Monitoring Report
FINAL VERSION
Horne Creek Tributaries Mitigation Project
Monitoring Year 2
Calendar Year of Data Collection: 2021

NCDEQ DMS Project Identification # 100026
NCDEQ DMS Contract # 7181
Yadkin River Basin (Cataloging Unit 03040101)
USACE Action ID Number: SAW-2017-01510
NCDEQ DWR Project # 2017-1156
Surry County, NC
Contracted Under RFP # 16-006993
Data Collection Period: October 2021
Submission Date: December 2021

RE: WLS Responses to NCDEQ DMS Review Comments for Task 8 Submittal, Monitoring Year 2 Report for the Horne Creek Tributaries Mitigation Project, DMS Full-Delivery Project ID #100026, Contract #7181, Yadkin River Basin, Cataloging Unit 03040101, Surry County, NC

FIGURE
 1a

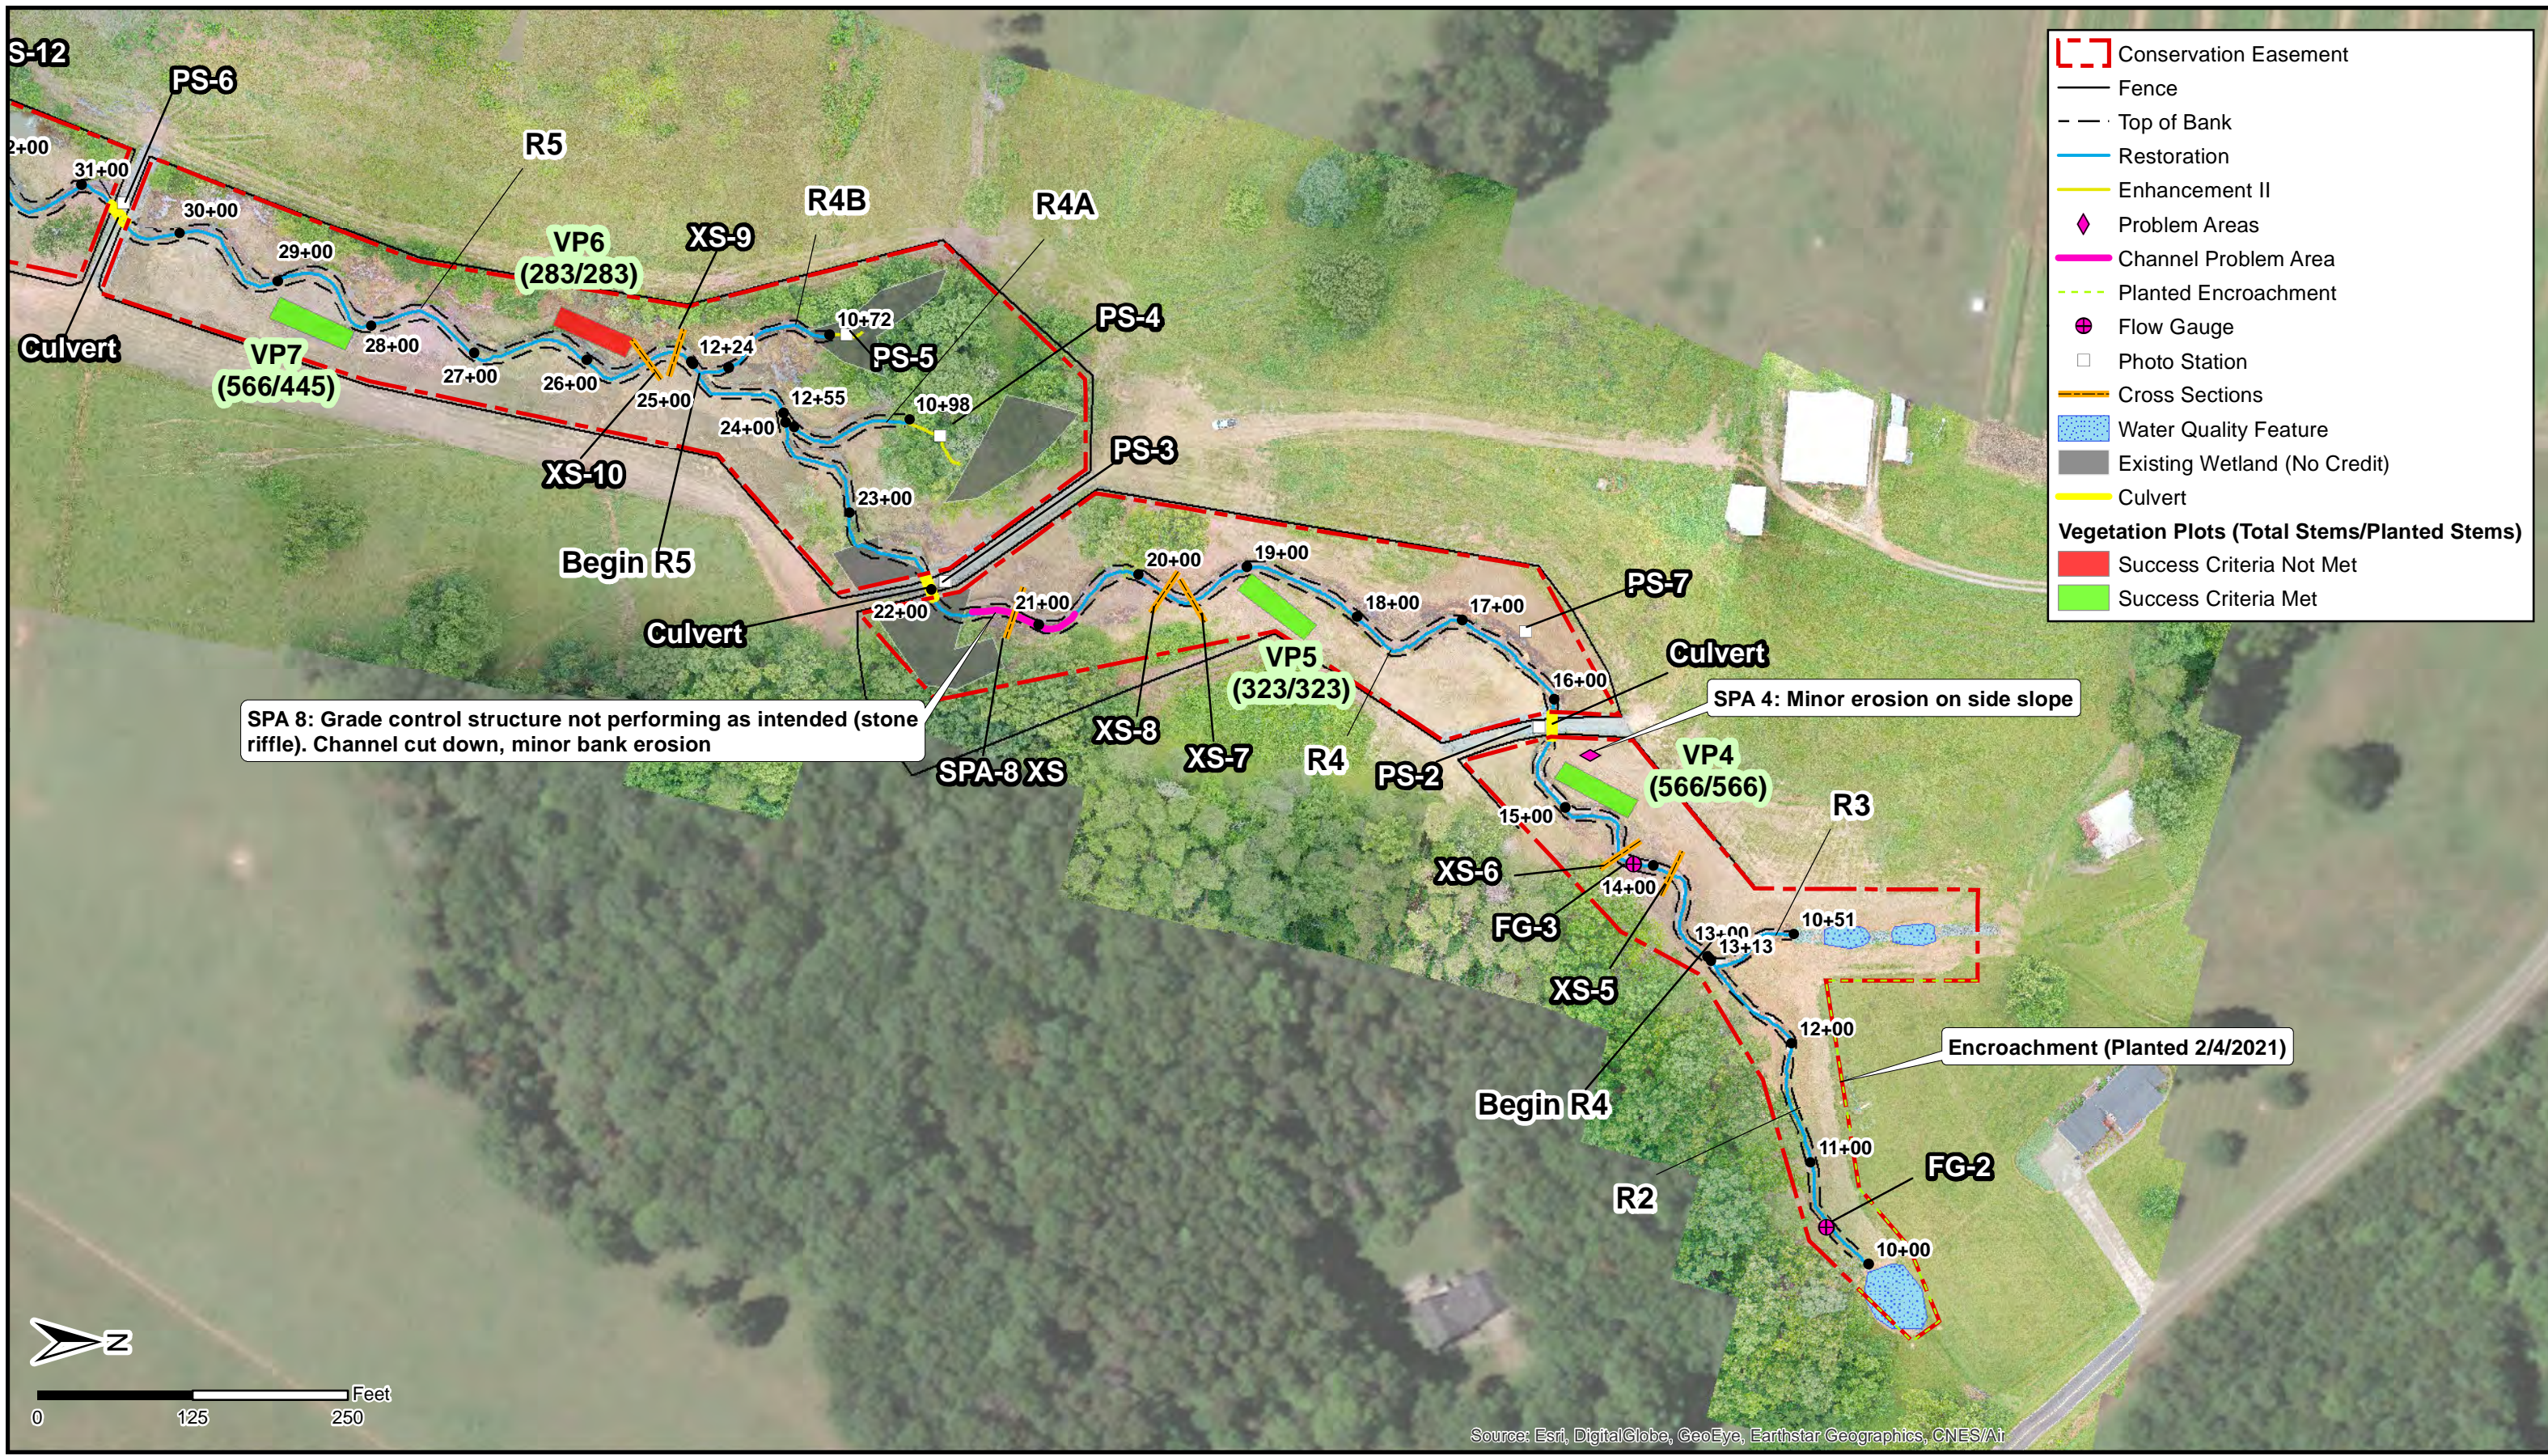
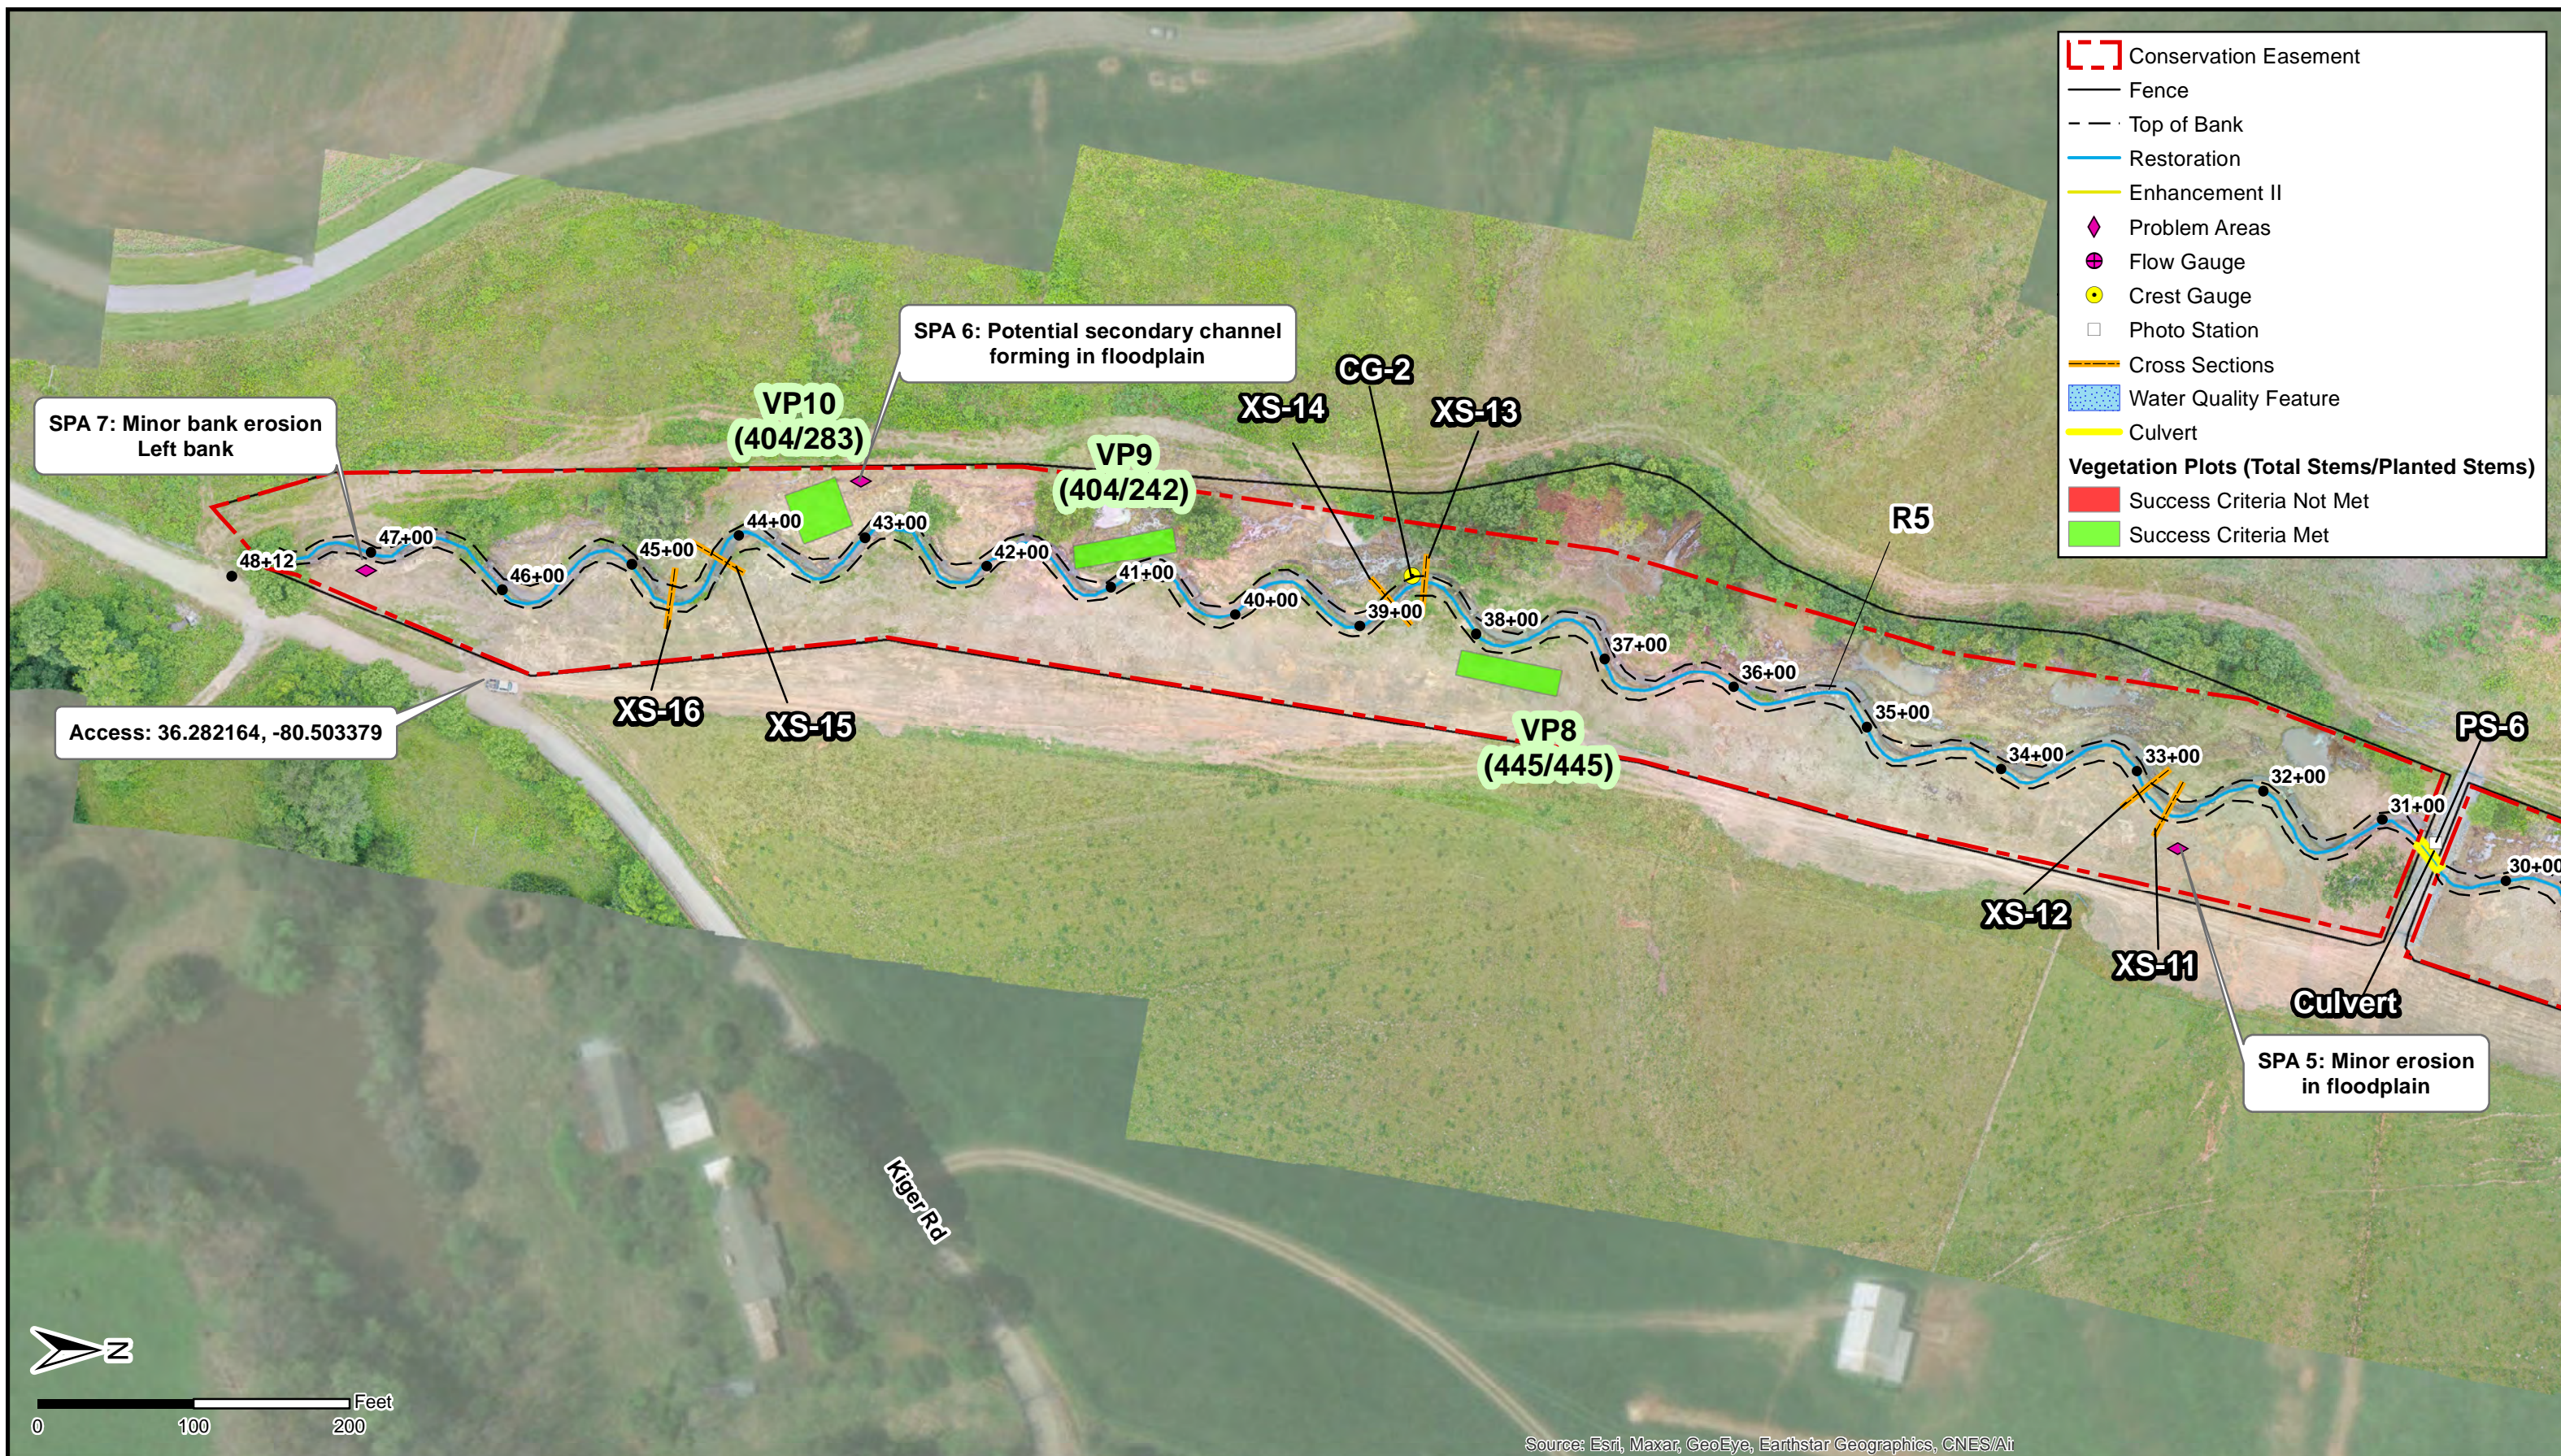
- **Table 2: Add “Livestake Planting/Maintenance – Feb 2021” to table.** Response: A row was added to capture this information.
- **CCPV: Consider adding reach breaks. It is difficult to know where R2, R4 and R5 transition between each other.** Response: Labels were added for reach breaks on the CCPV.

- **Table 5: There is one grade control structure listed as not performing as intended. Please use a call out or symbol for this structure on the CCPV.** Response: This area is called out on the CCPV as SPA8.

Project Name	Horne Creek Tributaries Mitigation Project
Project ID	100026
Reach ID	R4
Cross Section ID	SPA-8
Field Crew	K. Obermiller, C. Durham

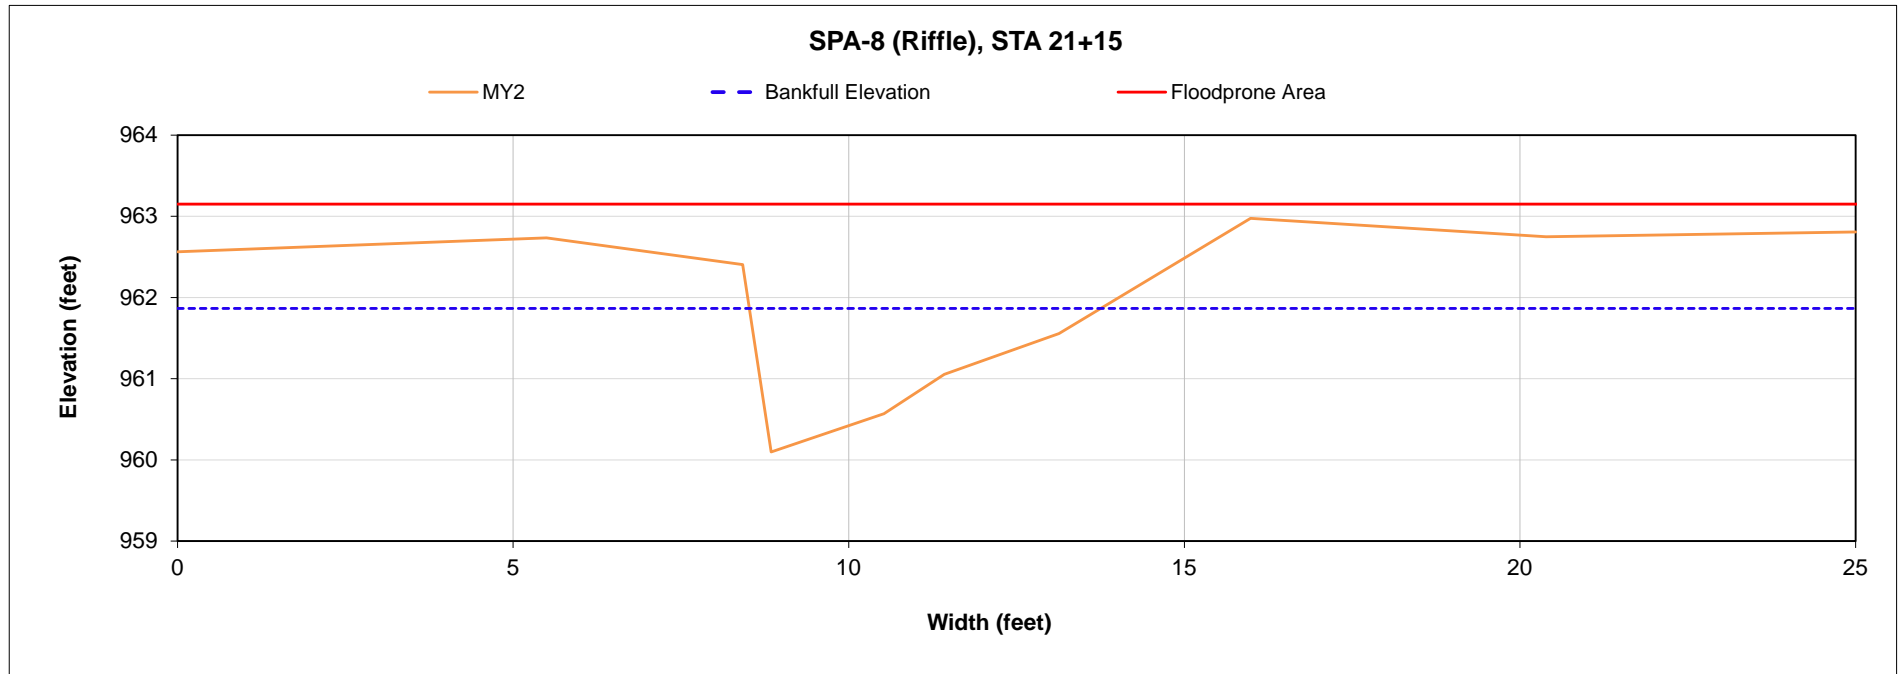
- **Please submit features characterizing the existing wetlands displayed on the CCPV.** Response: The existing wetlands shapefile is included in the e-data.
- **The length of the scoured/eroding segment is 91 feet according to the submitted feature. Please review and revise Table 5 or feature for consistency.** Response: Table 5 was revised to match the submitted feature.
- **Please submit a feature characterizing SPA-8’s cross section and include this feature on the CCPV.** Response: A cross-section feature was added to SPA-8 and is included in the e-data.
